Technical Service BULLETIN

REAR HATCH KNOCKING NOISE

'05 – '06 Scion tC

NV010-06
H/VH

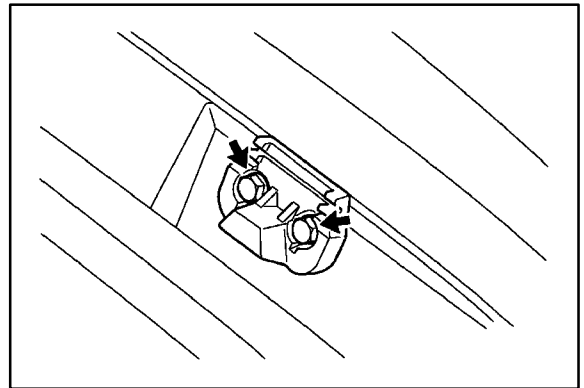
- Remove the back door lower stopper cushion on the left and right side by removing the 2 bolts.
- Install a NEW stopper cushion on the left and right side with 2 bolts.
Torque: 4.0 N•m (41 kgf•cm, 35 in.·lbf)

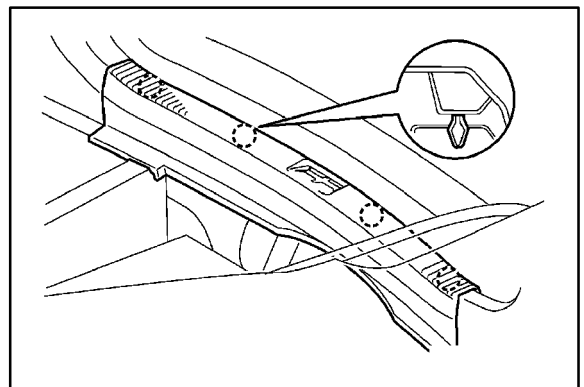
- Adjust the striker down approximately 2 mm (0.08 in.).
 - Using a taped screwdriver or the plastic trim tool, detach the 4 claws and remove the finish panel.

- B. Slightly loosen the striker mounting screws and tap the striker down 2 mm (0.08 in.) with a plastic-faced hammer.
- C. Tighten the striker mounting screws after the adjustment.
**Torque: 23.0 N•m
(234 kgf•cm, 17 ft•lbf)**
4. Reinstall the finish panel.
5. Confirm that hatch noise is gone.
